# CARDONE ProTech

## Water Intrusion Causes Many Wiper Motor Problems

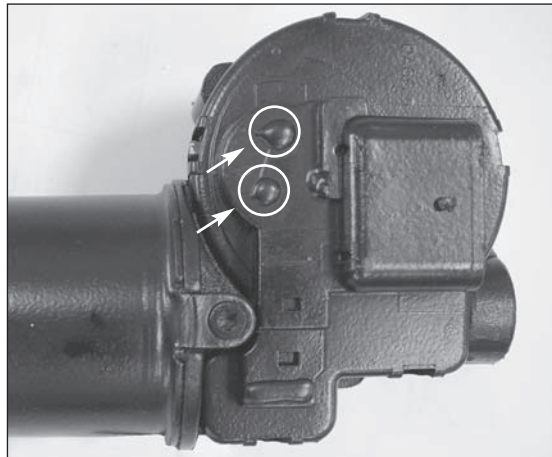
**Problem** Wiper motors with and without integrated electronic pulse board not working properly or at all.

**Cause** Wiper motor and/or electronic components may have failed due to water intrusion.

**Solution** To protect the replacement wiper motor and pulse board, be sure water does not drain on wiper motor assembly. Remove any debris that might block or restrict the flow of drain water to the left or right fender well areas. Be sure to also check for proper operation of control switch and associated wiring.

To prevent water intrusion, our replacement units are re-engineered to overcome original design flaws. Vent holes that allow water entry are blocked, therefore protecting the motor & its electronic components.
